CHATSWOOD TO SYDENHAM  
**VICTORIA CROSS STATION  
AND ARTARMON SUBSTATION  
MODIFICATION  
SUBMISSION REPORT**

# Executive summary

Figure 2-2 Revised setbacks – Victoria Cross Station

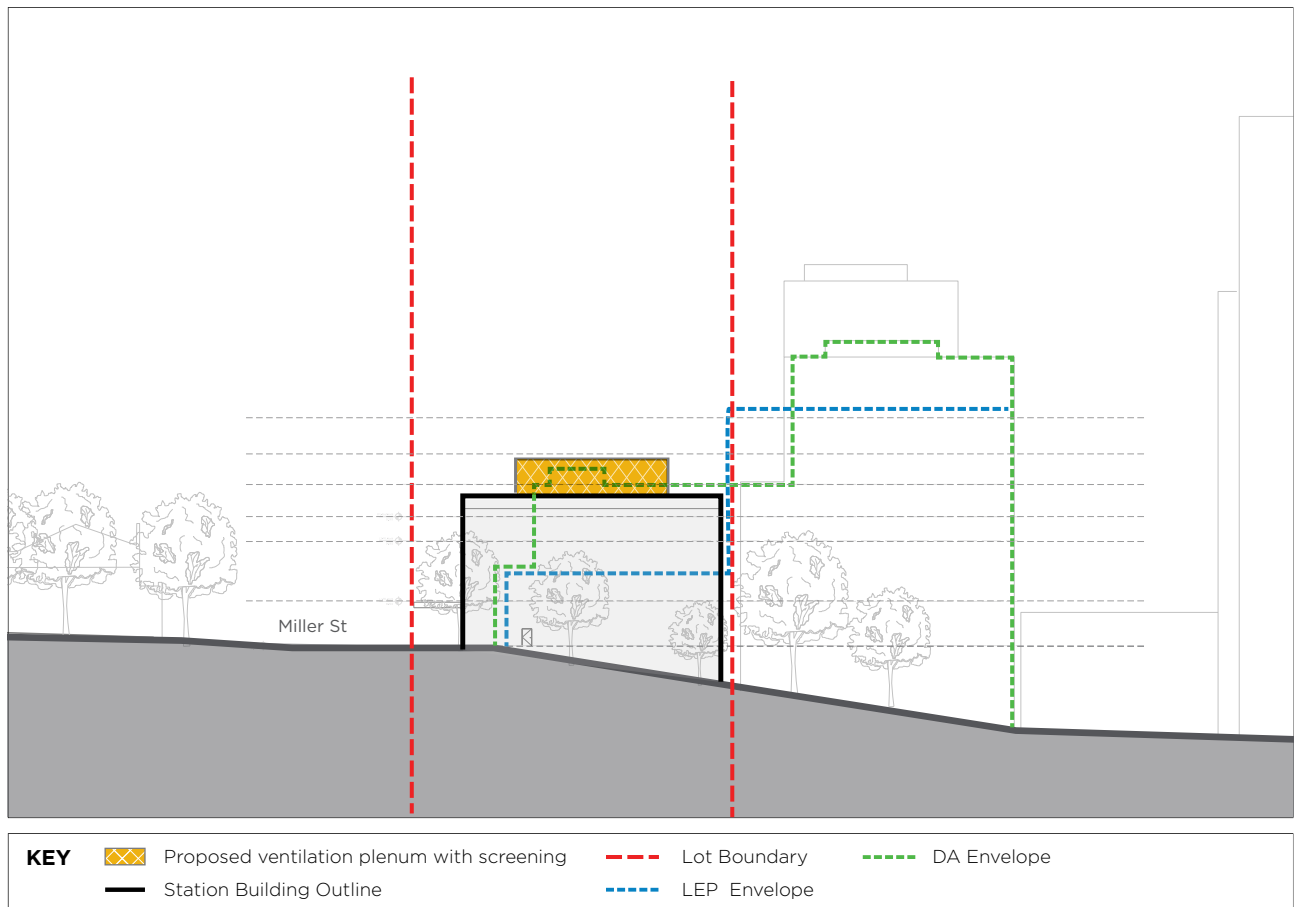
The setback to McLaren Street has been reduced from 4.5 metres to 1.2 metres. This was required to allow an increase in the setback to the boundary with 243 Miller Street (to around 3.3 metres) and reduce potential impacts on several trees at that location. The revised setbacks are shown in plan view on Figure 2-2 and as a cross section (for the Miller Street setback) on Figure 2-3.
